Access Compliance Report

Public Rights-of-Way

(Curb Ramps)

Intersection ID: 52927	Main Street: EMORY_OAK_DR	Cross Street: GRAY_OAK_LN	Location: NW
ADA ID: FFC2EC2B60E7	Ramp Type: Perp	Initial Pass/Fail: Fail	Overall Compliance: No
		Severity Score: 22.5

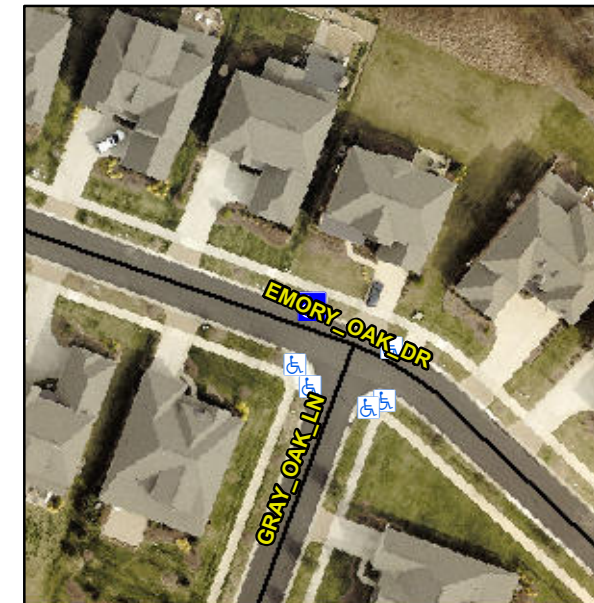
R304.5.1, R304.2.2, R304.5.3

Compliance	Description	Data	Compliance	Description	Data
N/A	Ramp Length (in)	95.0	No	Ramp Slope (%)	9.0
No	Ramp Width (in)	46.0	No	Ramp XSlope (%)	2.5
N/A	Flare Type LT	N/A	N/A	Flare Type RT	N/A
N/A	Flare Slope LT (%)	N/A	N/A	Flare Slope RT (%)	N/A
N/A	Flare Traversable LT?	N/A	N/A	Flare Traversable RT?	N/A
N/A	Landing Length (in)	N/A	N/A	DWS Provided?	N/A
N/A	Landing Width (in)	N/A	N/A	DWS Contrast?	N/A
N/A	Landing Slope (%)	N/A	N/A	DWS Length (in)	N/A
N/A	Landing X Slope (%)	N/A	N/A	DWS Full Width?	N/A
N/A	Landing Curb? (Y/N)	N/A	N/A	DWS Offset (in)	N/A
N/A	Shared Landing?	N/A			
N/A	Gutter Ponding?	N/A	N/A	Gutter Slope (%)	N/A
N/A	Gutter Lip Ht (in)	N/A	N/A	Gutter X Slope (%)	N/A
N/A	Painted X Walk1?	No	N/A	Painted X Walk2?	N/A
	X Walk 1 Direction	To S		X Walk 2 Direction	N/A
N/A	X Walk 1 Width (in)	N/A	N/A	X Walk 2 Width (in)	N/A
	X Walk 1 Slope (%)	2.7		X Walk 2 Slope (%)	N/A
	X Walk 1 X Slope (%)	1.8		X Walk 2 X Slope (%)	N/A

Remove & Replace Entire Ramp.
